REVIEW COMMENTS

FILE #95-94

TITLE HEADING: Site Plan Review - Warehouse

LOCATION: 595-7 North Westgate

SHEET
 1

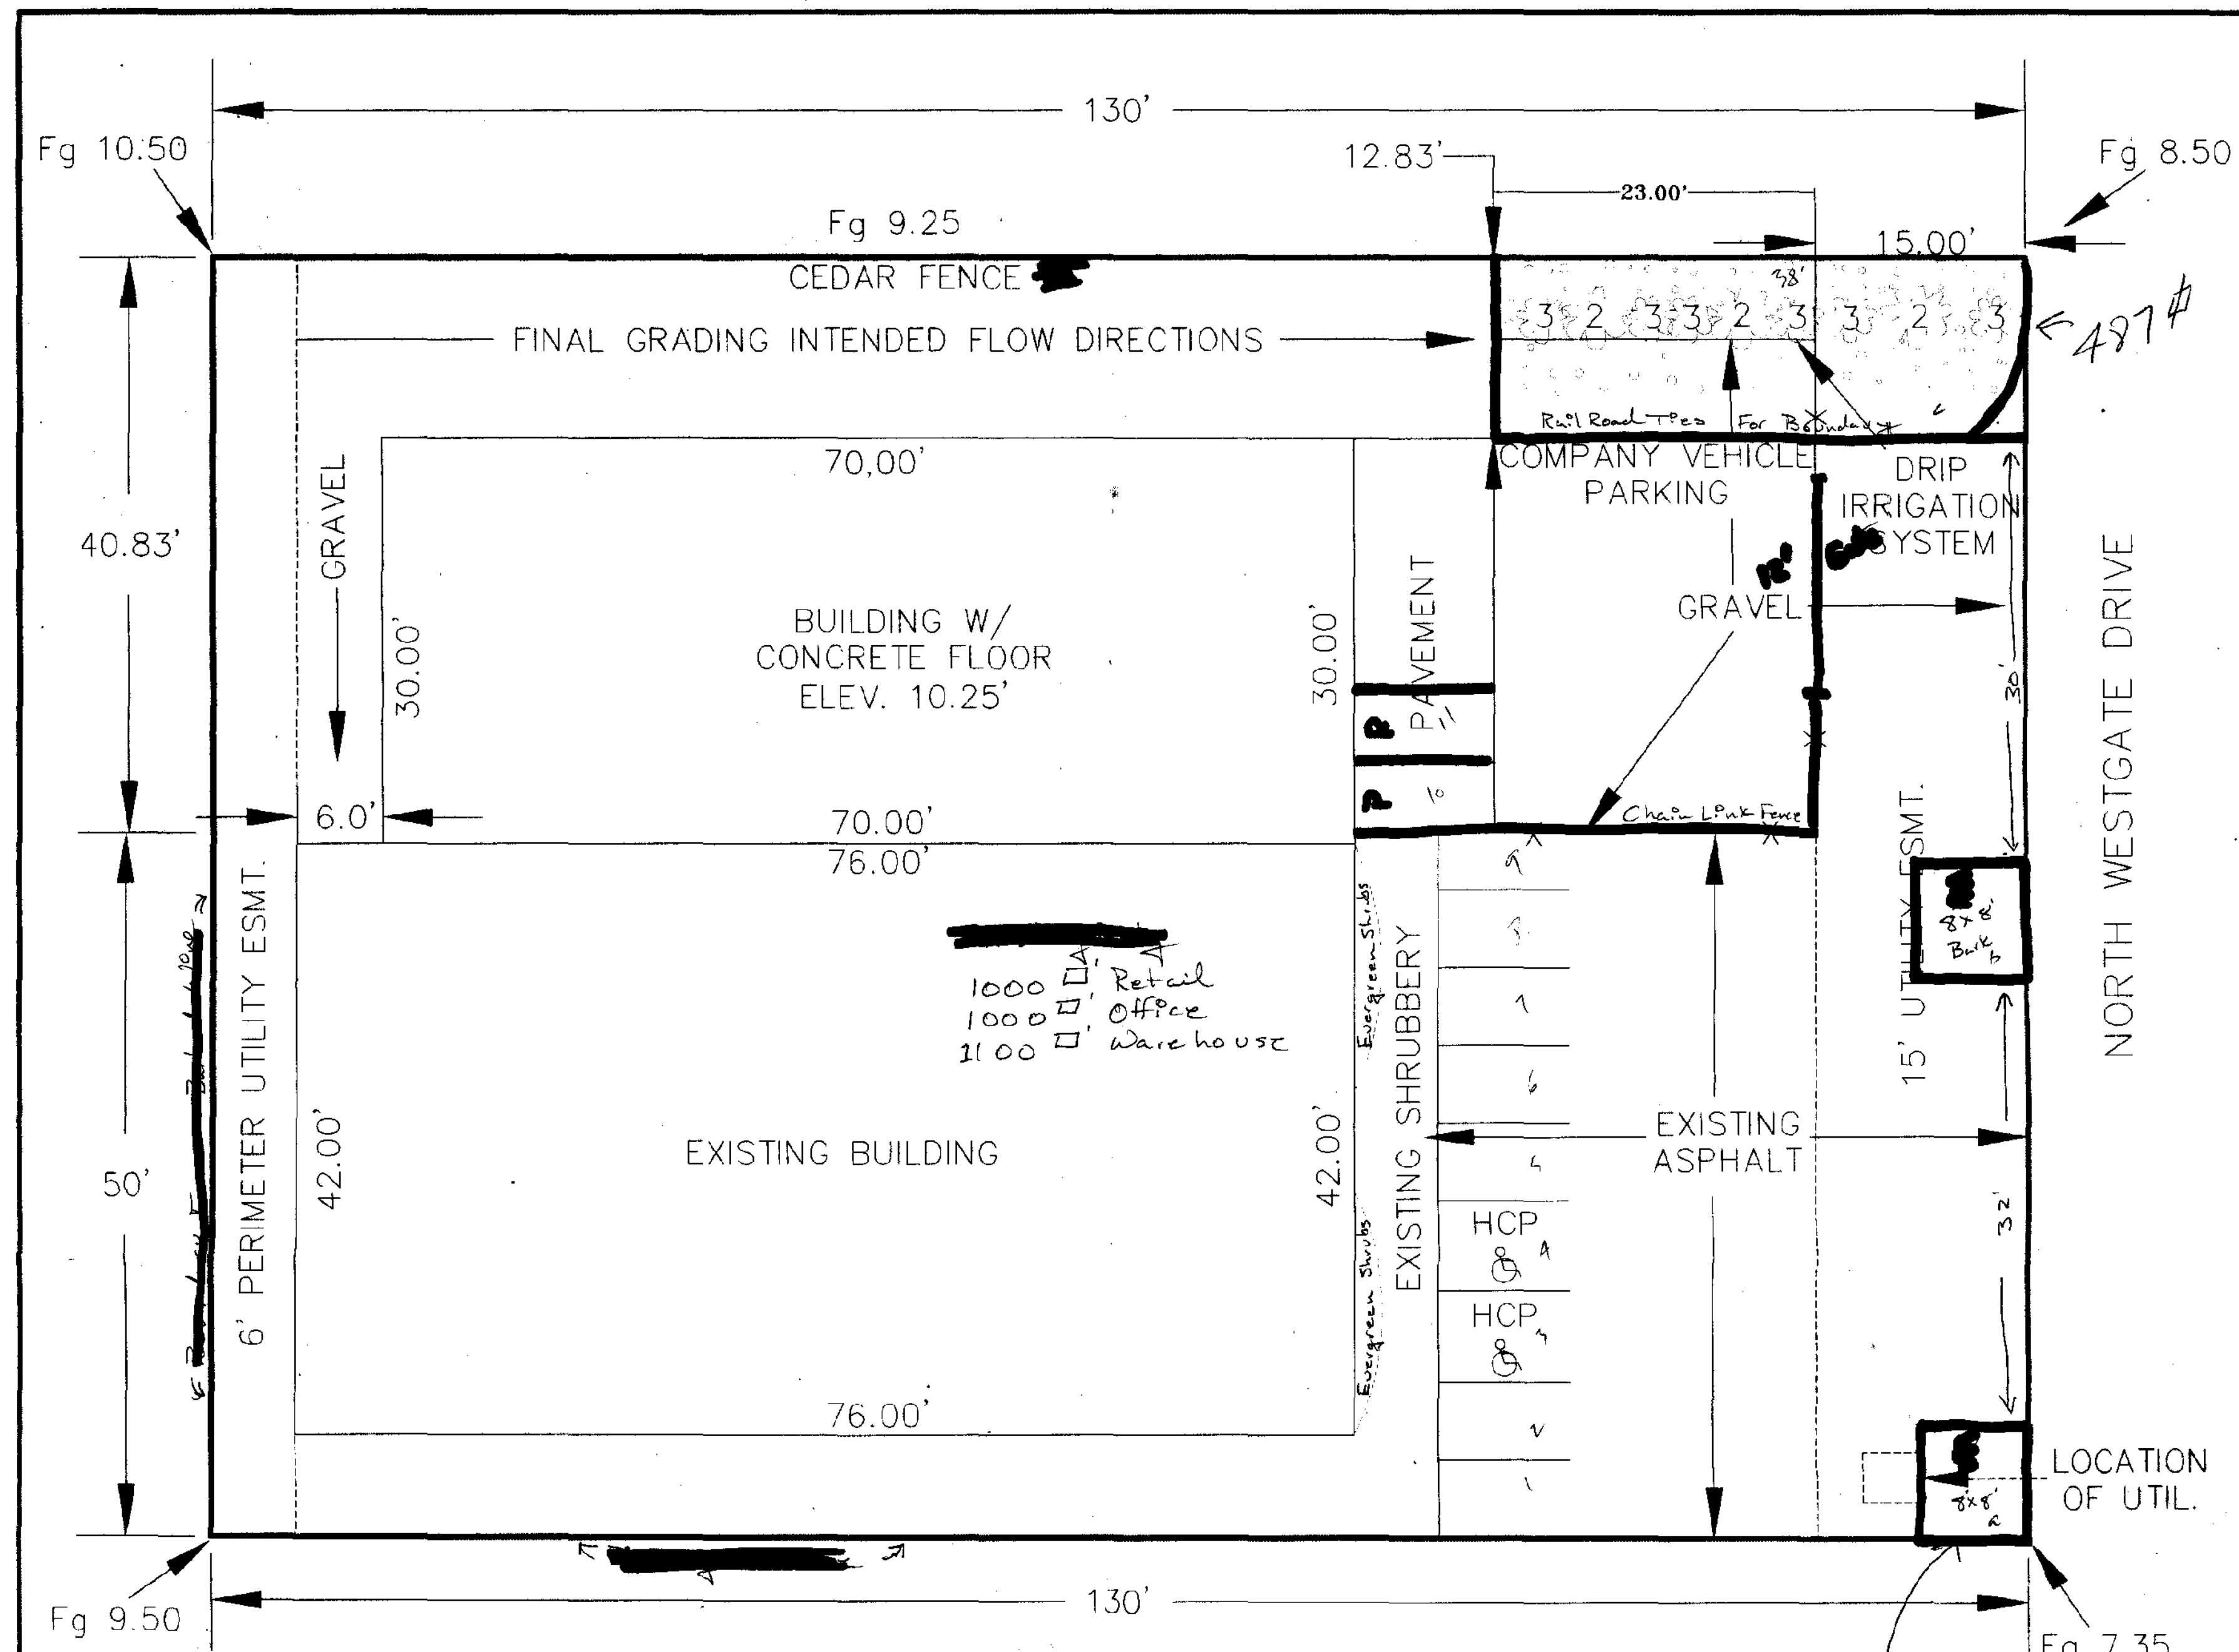
1. Need defined driveways rather than the entire frontage paved and open. See attached curb cut standards.
2. Drainage fee is applicable - \$879.79 for plan as shown. May be reduced some if driveways are defined with landscaping in between driveways.

1. Total parking requirement cannot be determined without more information regarding the building--how much square footage of office space and retail sales area is there within the existing building? The parking requirement for the addition is 2 spaces.
2. Only one handicap stall is required.
3. Define driveways into site with curbing (see Development Engineer comments).
4. Is there a gate in the fencing to access the "company vehicle parking" area?

1. The total on-site landscape requirement is approximately 514 square feet. The areas shown, between existing and proposed meet this requirement; however, more detail is needed on the plan:
 - landscaped area along north side must be contained with curbing
 - what is species of deciduous trees?
 - also indicate planting size of trees (1-1/2" caliper is minimum)
2. Recommend that, once driveway(s) is defined, there be some landscaped area in front (probably would be in the right-of-way) to reinforce driveway definition and reduce drainage fee.
3. How tall is cedar fence and does it go all the way around the site or just along north side? Is what appears to be fencing in front (shown with x's) also cedar or chain link or . . . ?

1. Will the off-premise sign currently behind the Klumb's building along Patterson Road be removed? reused by some other business?

As per Conversation with Jody, we have added driveway partitions/
with railroad ties and cedar bark (see attached plans)

Square footage breakdown of existing building, 1000sqft retail, 1000sqft
office, 1100 sqft warehouse.

There is a 12' gate on the fence toward N. Westgate Dr..

Landscaped area will be curbed with railroad ties, the trees will be
1 1/2 " caliper elm,

The driveway definition has been made more definable.

The cedar fence is 6' in height (see attached plan revision).

The off premise sign will be removed.

revisions: ~~_____~~
 The sign in question will come down.
 parking
 1/200# retail = 5
 1/300# office = 4
 1/ company vehicle warehouse = 2
 + employees per shift 11 req'd.
